PAJARO VALLEY WATER MANAGEMENT AGENCY

Subject: Addendum No. 1. Request for Proposals (RFP) to Provide Design and Bid Period Services for the Watsonville Slough System Managed Aquifer Recharge and Recovery Projects

WSS-MARR Project Components

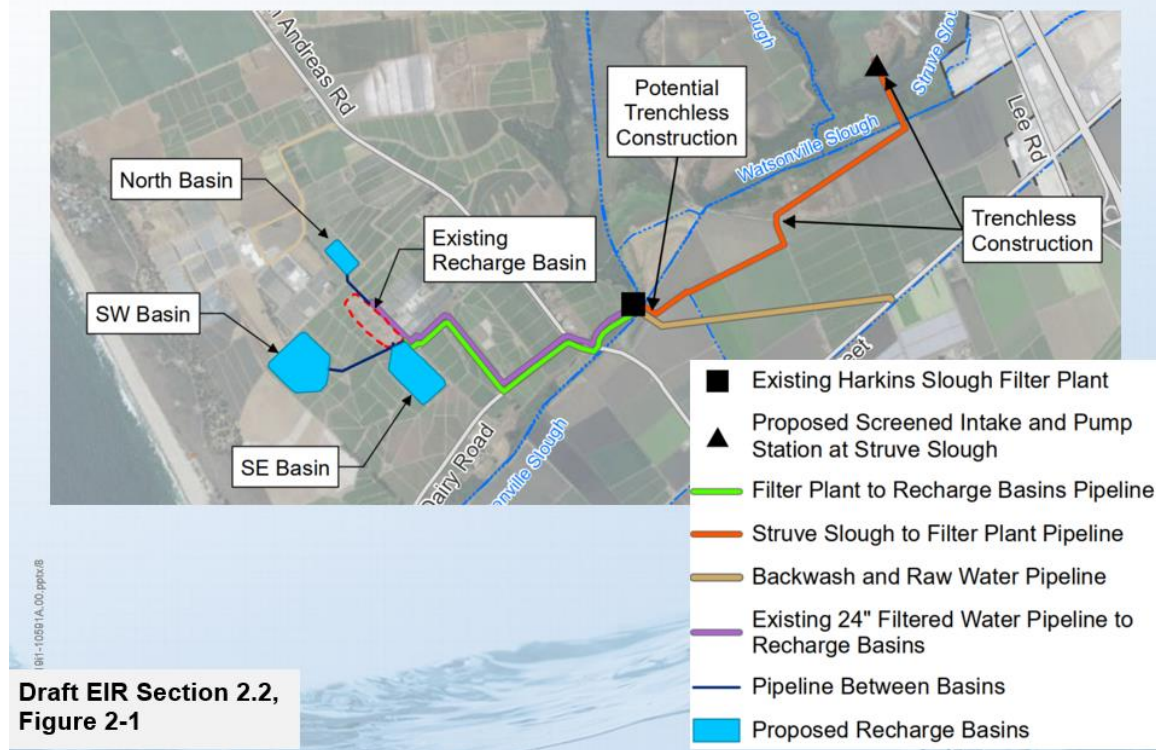
The following project components *should not* be included in proposals:

- Filter Plant to Recharge Basins Pipeline (Green Line)
- North Basin
- SW Basin
